Project Name: Cavanaugh & Cumberland HVACProject No.: 221125-020 & 030Architect: KingscottDate: 12/18/2023Bid Package No.: 2Bid Due Date: 12/21/2023

This Addendum is issued to inform the bidders of modifications in the scope of work being bid for this project.

- Specification section(s):
  - BDN Abatement Technical Specifications - Cumberland 12/06/2023 [REVISED]
- Drawing(s):
  - M0.5 – Roof Composite Mechanical Plan [REVISED]
  - E7.0 – Electrical Diagrams, Schedules and Details [REVISED]
  - EP0.5 – Roof Composite Power Plan [REVISED]
  - EPI.2 – Power Plan - Unit 200 [REVISED]

**ROOF COMPOSITE MECHANICAL PLAN**  
SCALE: 1/16" = 1'-0"

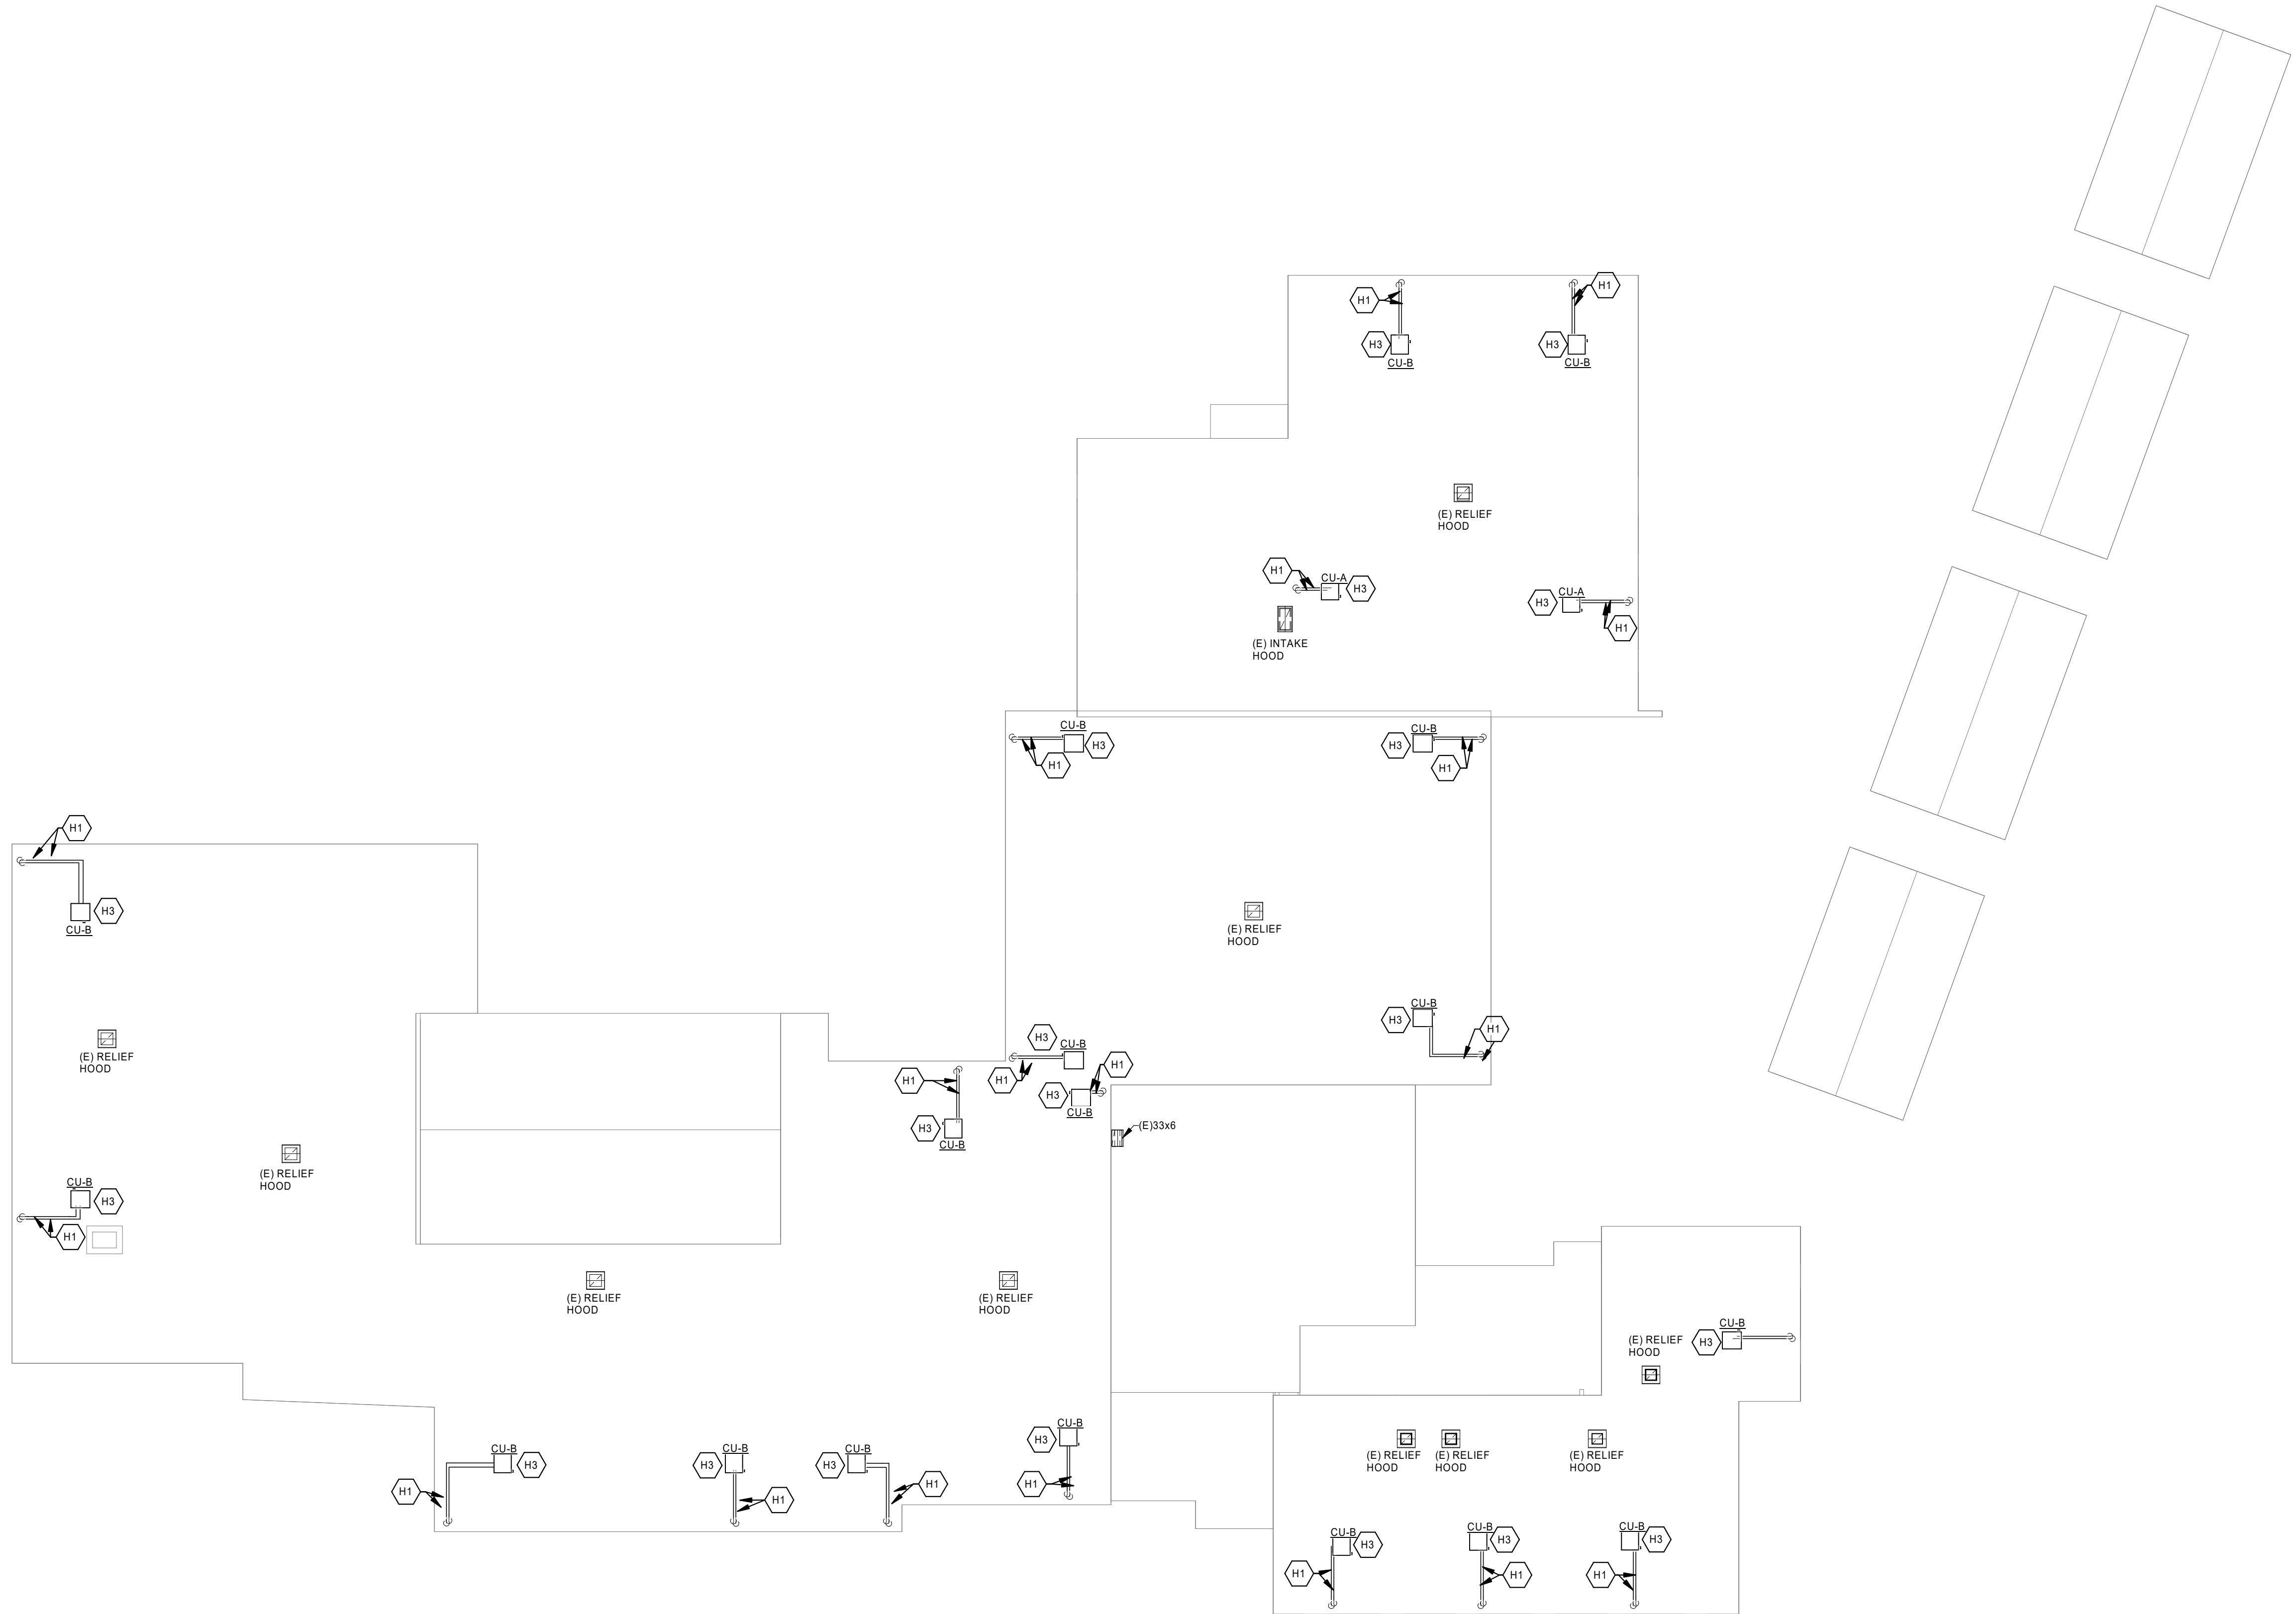
- H3 ~~PROVIDE~~ CONDENSING UNIT ON EQUIPMENT STAND. ENSURE CONDENSING UNIT IS MINIMUM 1'-0" FT FROM ROOF EDGE.
- H4 EXISTING LOUVER IS APPROXIMATELY 51"X10 3/8". PROVIDE NEW 60"X10 3/8", 2" DRAINABLE BLADE LOUVER. FIELD VERIFY AND REVISE OPENING SIZE AS REQUIRED FOR NEW LOUVER. NEW LOUVER HEIGHT TO MATCH EXISTING LOUVER HEIGHT AND BE 4 BRICK COURSINGS TALL. COORDINATE WITH ARCHITECTURAL TRADES.

- H5 EXISTING LOUVER OPENING IS APPROXIMATELY 76"X10 3/8". PROVIDE NEW 76"X10 3/8", 2" DRAINABLE BLADE LOUVER TO MATCH EXISTING OPENING. NEW LOUVER HEIGHT TO MATCH EXISTING LOUVER HEIGHT AND BE 4 BRICK COURSINGS TALL. FIELD VERIFY AND REVISE OPENING SIZE AS REQUIRED FOR NEW LOUVER. COORDINATE WITH ARCHITECTURAL TRADES.

- H6 EXISTING LOUVER OPENING IS APPROXIMATELY 56"X10 3/8". PROVIDE NEW 60"X10 3/8", 2" DRAINABLE BLADE LOUVER. FIELD VERIFY AND REVISE OPENING SIZE AS REQUIRED FOR NEW LOUVER. NEW LOUVER HEIGHT TO BE 4 BRICK COURSINGS TALL AT MATCH HEIGHT OF EXISTING LOUVER. COORDINATE WITH ARCHITECTURAL TRADES.

POWER PLAN - UNIT 200  
SCALE: 1/8" = 1'-0"

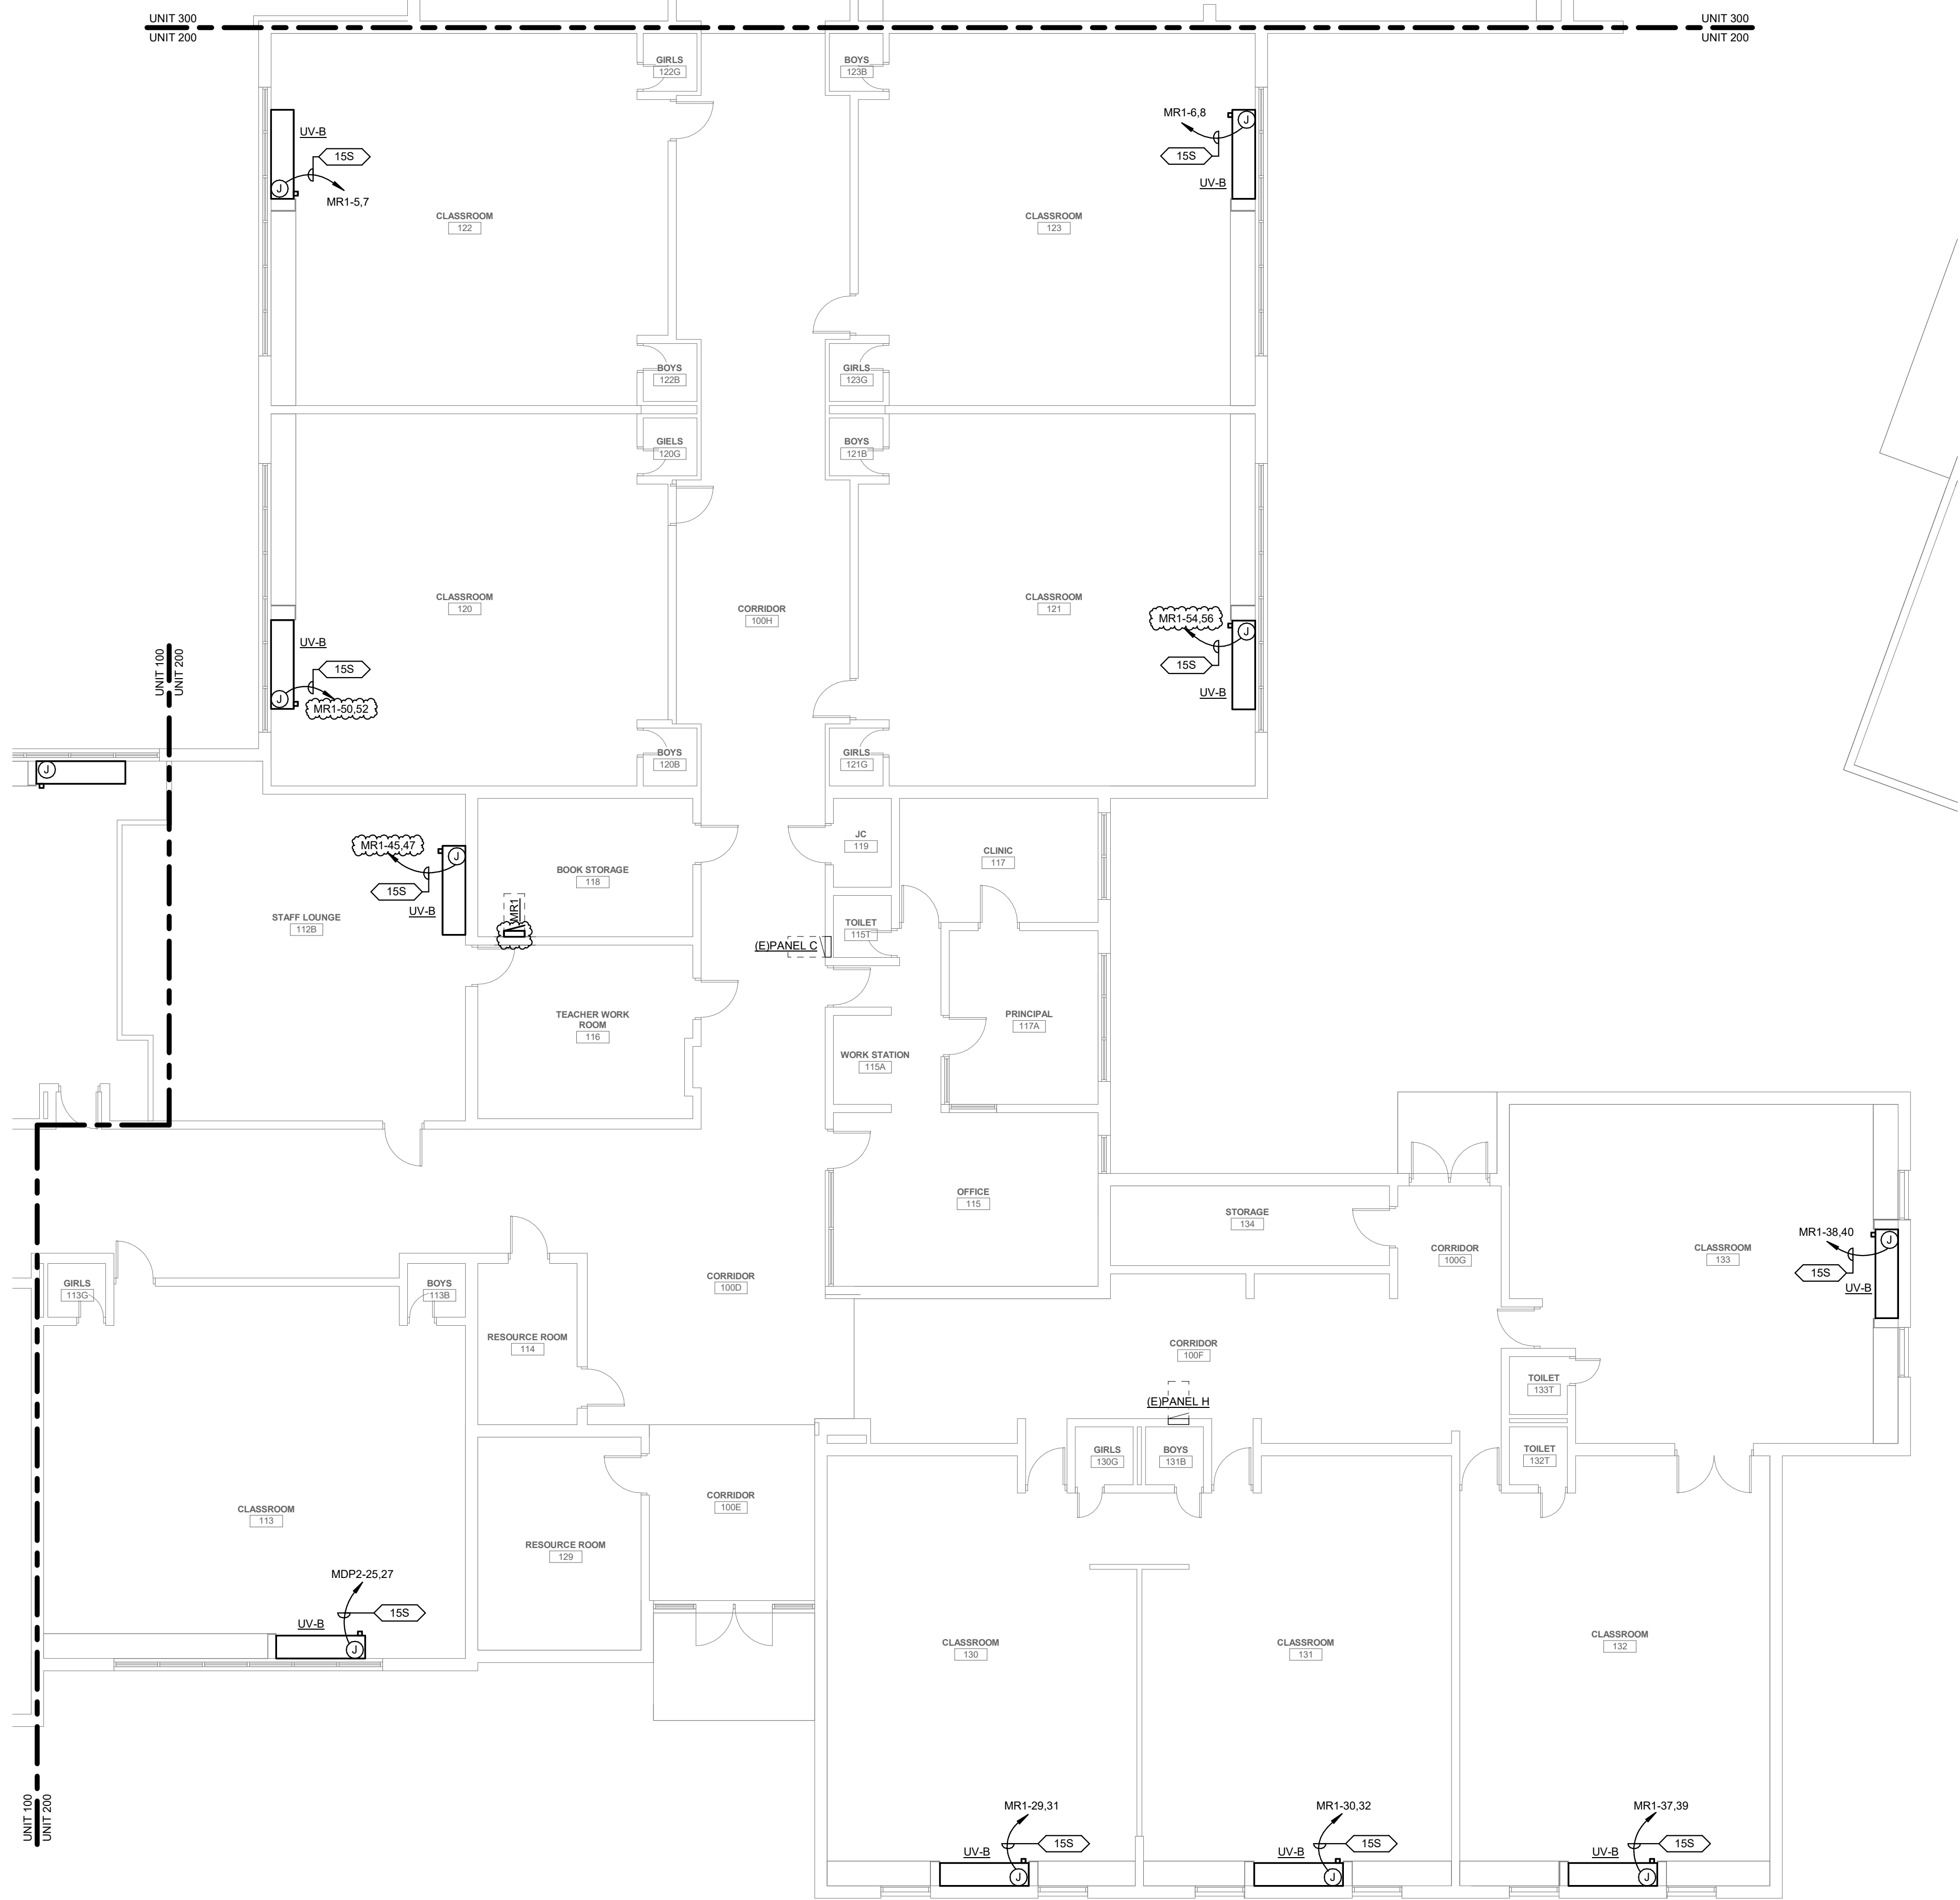
- R1 REFER TO E7.0 FOR COMPLETE ELECTRICAL ROOM NEW SCOPE AS INDICATED IN NEW WORK ELECTRICAL RISER DIAGRAM
- R2 ELECTRICAL CONTRACTOR TO VERIFY NEW EQUIPMENT WILL FIT THROUGH STANDARD 3' X 7' DOOR PRIOR TO ISSUING SUBMITTAL OR PURCHASING EQUIPMENT.
